**BVPS CONVERSION TO IMPROVED STANDARD
TECHNICAL SPECIFICATIONS (ISTS)**

SECTION 3.3A Reactor Trip System Instrumentation

**MARKUPS TO SHOW BVPS PLANT SPECIFIC DIFFERENCES
&
JUSTIFICATION FOR DEVIATION (JFD)
FROM THE STANDARD TS**

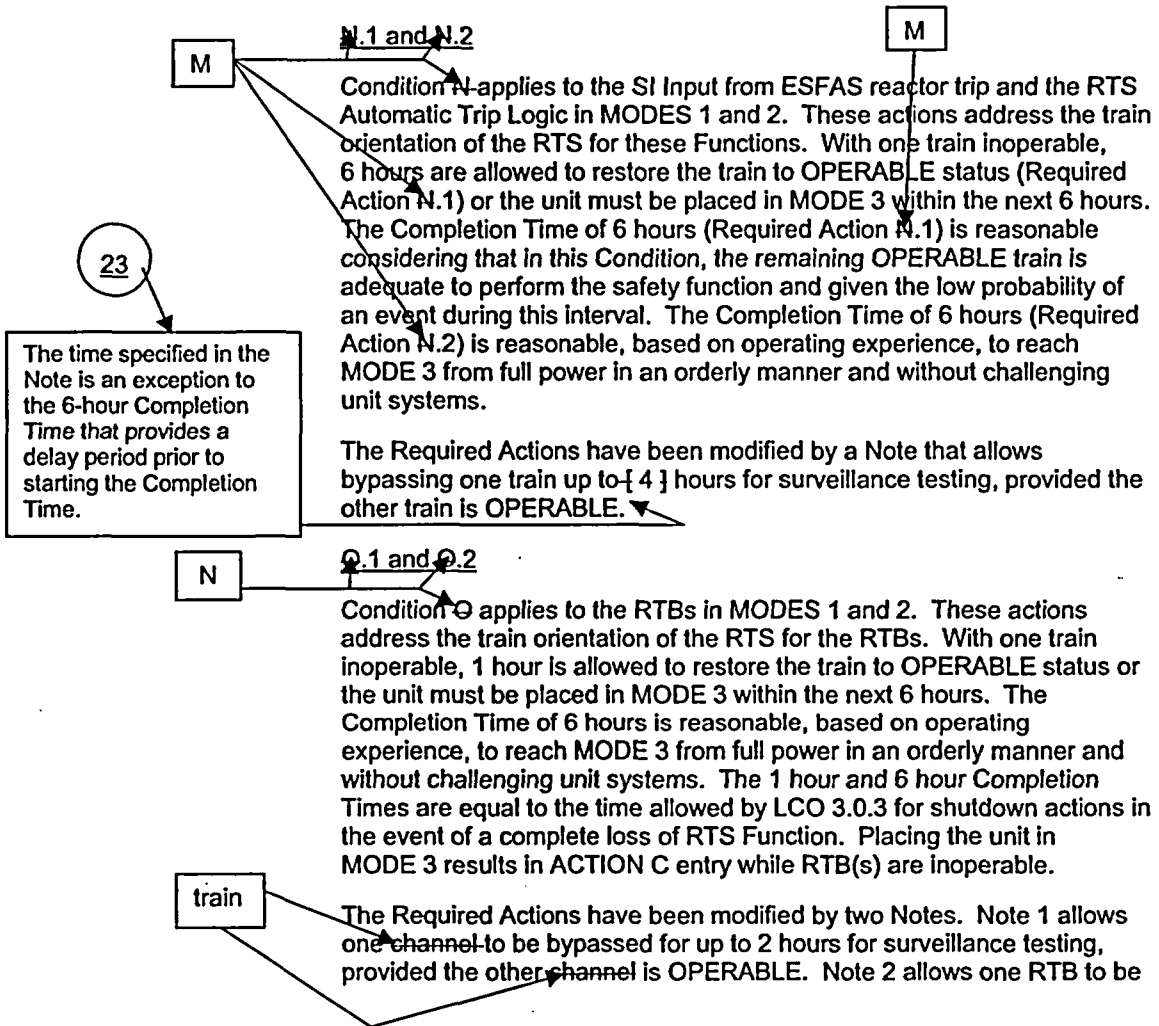
not true for Stop Valve Closure Function

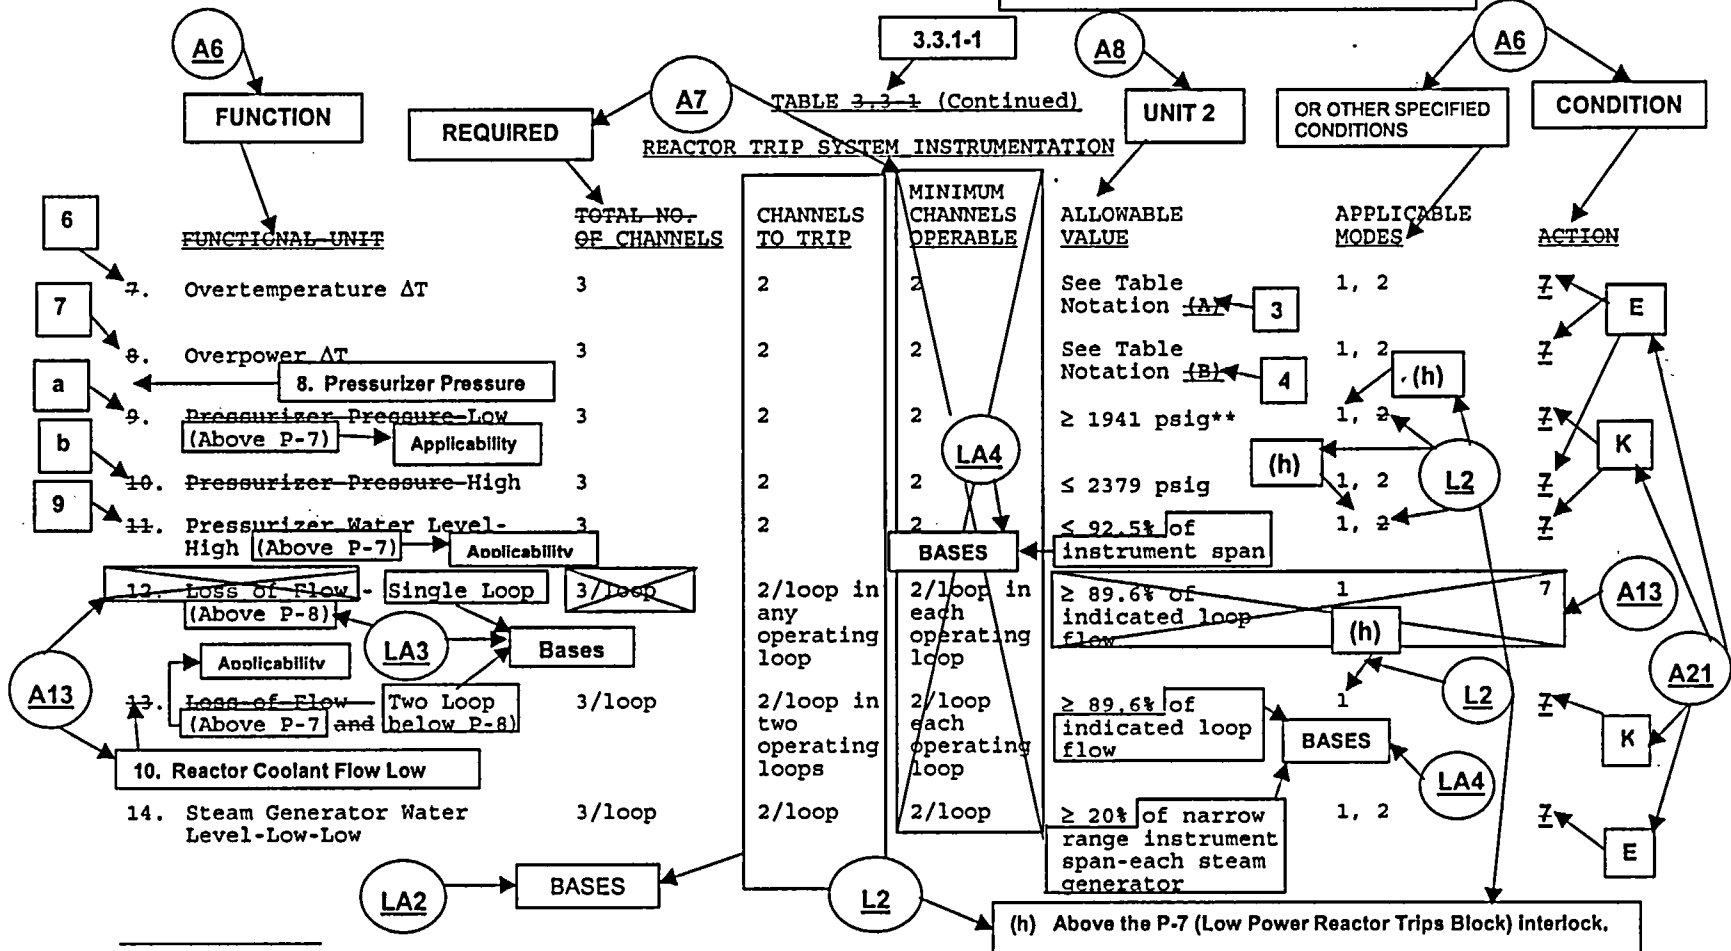
(8) Alternate detectors may only be used for monitoring purposes Without Rod Withdrawal Capability until detector functions are modified to permit equivalent alarm and trip functions.

** Time constants utilized in the lead-lag controller for Pressurizer Pressure-Low are ≥ 2 seconds for lead and ≤ 1 second for lag. Channel calibration shall ensure that these time constants are adjusted to those values.

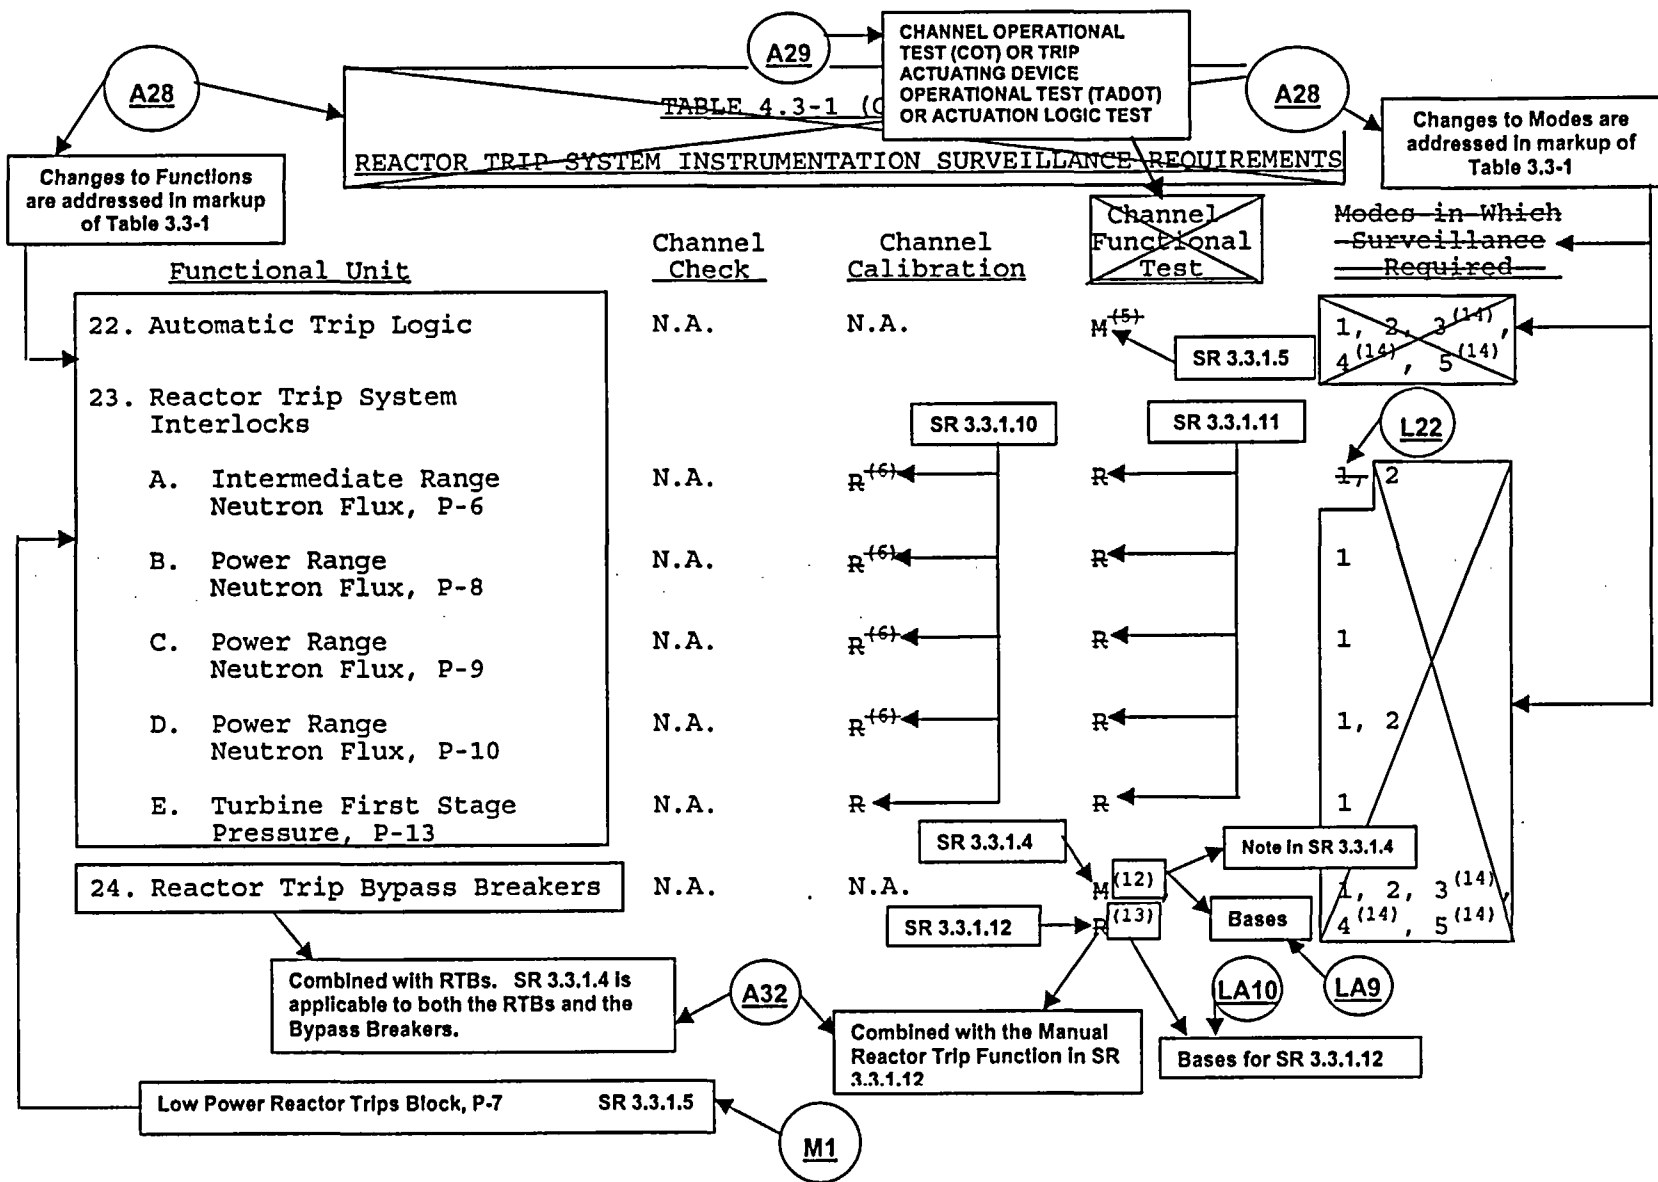
Adjust power range channel if calorimetric heat balance calculation results exceed power range channel output by more than + 2% RTP. Not required to be performed until 24 hours after THERMAL POWER is \geq 15% RTP.

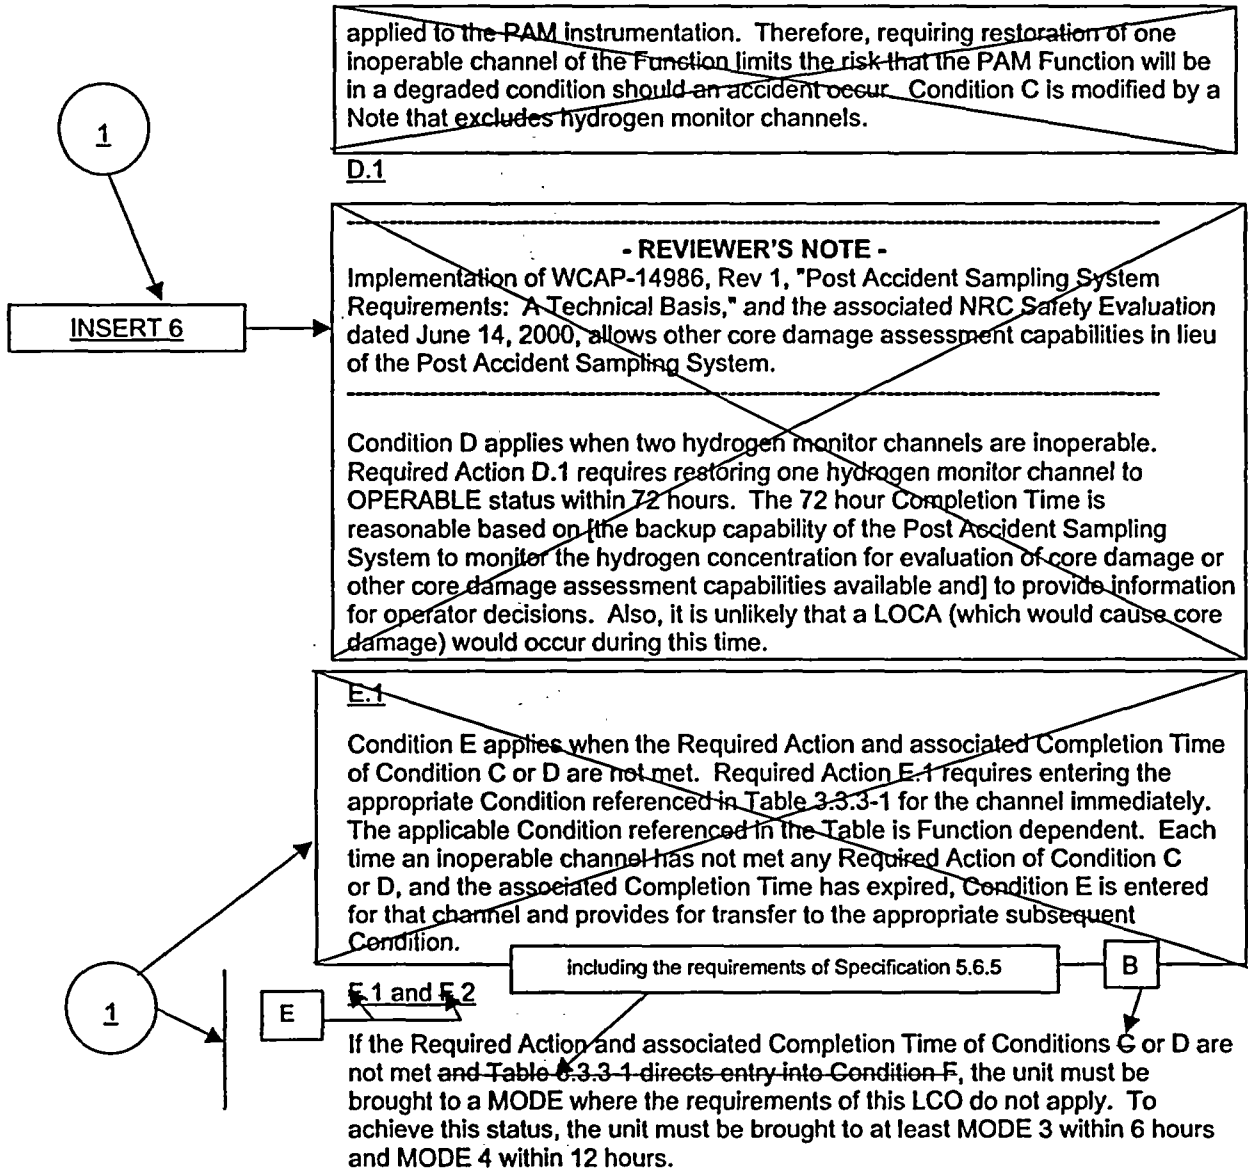
TSTF-359 → A → Note 2 has been added in the ACTIONS to clarify the application of Completion Time rules. The Conditions of this Specification may be entered independently for each Function listed on Table 3.3.3-1. The Completion Time(s) of the inoperable channel(s) of a Function will be tracked separately for each Function starting from the time the Condition was entered for that Function.

1 → INSERT 4 → ~~A.1~~
~~Condition A applies when one or more Functions have one required channel that is inoperable. Required Action A.1 requires restoring the inoperable channel to OPERABLE status within 30 days. The 30 day Completion Time is based on operating experience and takes into account the remaining OPERABLE channel (or in the case of a Function that has only one required channel, other non-Regulatory Guide 1.97 instrument channels to monitor the Function), the passive nature of the instrument (no critical automatic action is assumed to occur from these instruments), and the low probability of an event requiring PAM instrumentation during this interval.~~

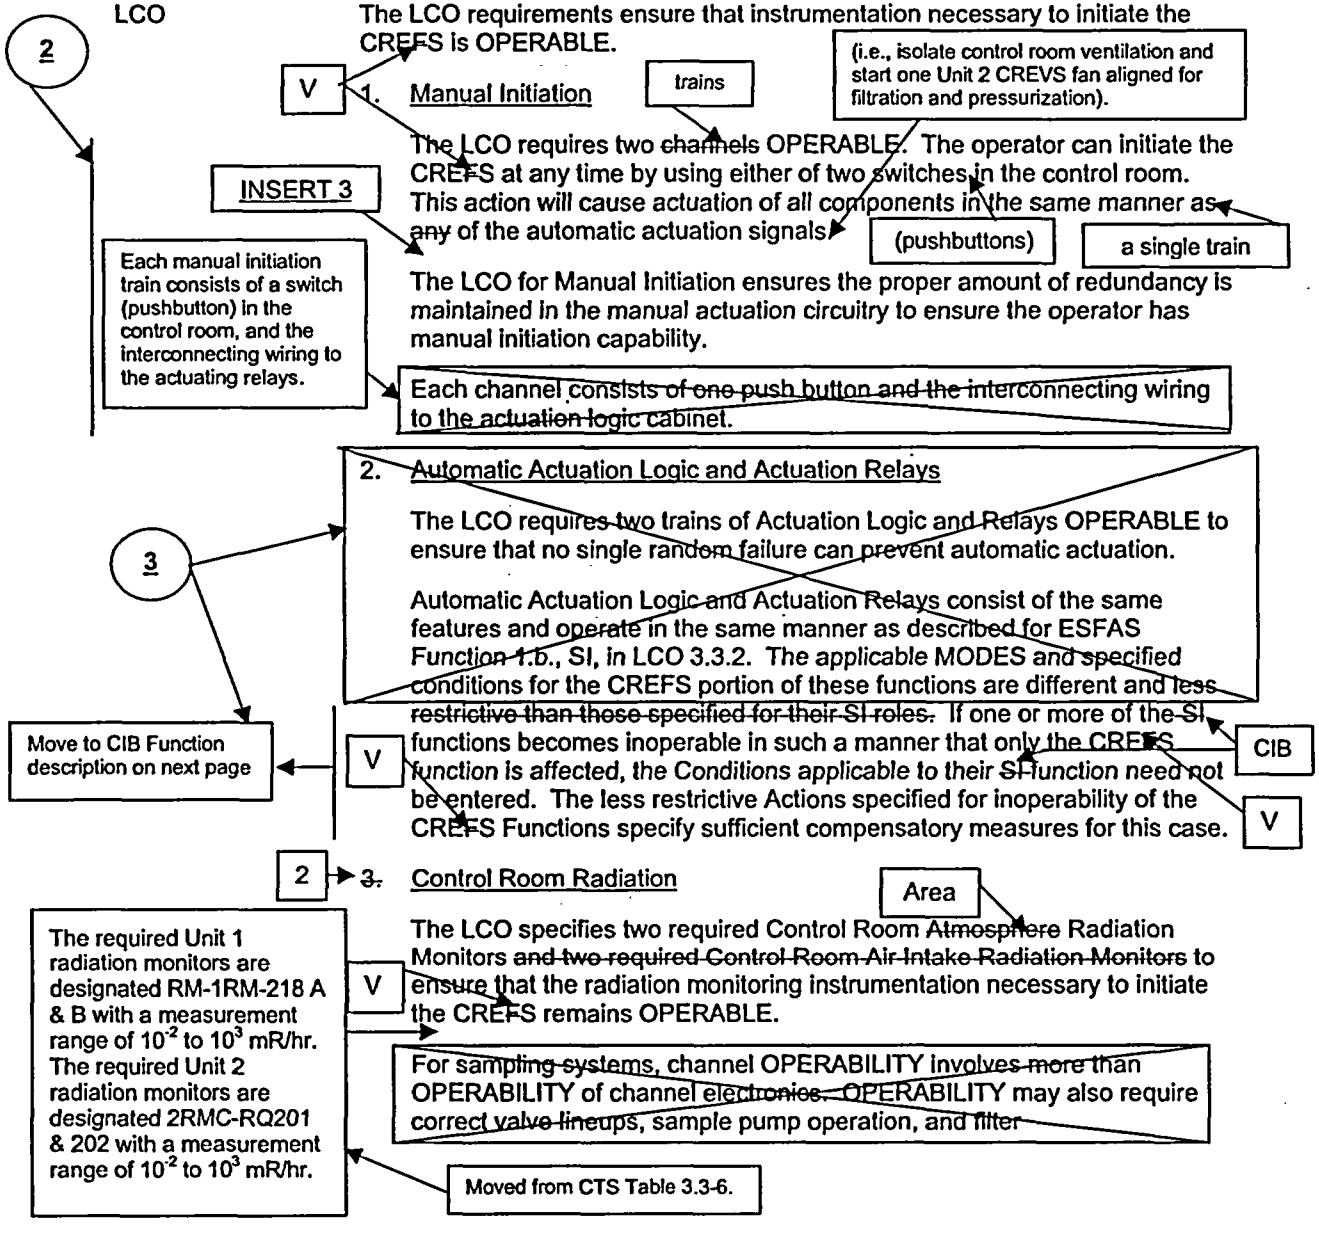
~~In MODES 1, 2, 3, and 4, the radiation monitor actuation of the CREFS is a backup for the SI signal actuation. This ensures initiation of the CREFS during a loss of coolant accident or steam generator tube rupture.~~

~~The radiation monitor actuation of the CREFS in MODES 5 and 6, and during movement of [recently] irradiated fuel assemblies are the primary means to ensure control room habitability in the event of a fuel handling or waste gas decay tank rupture accident.~~
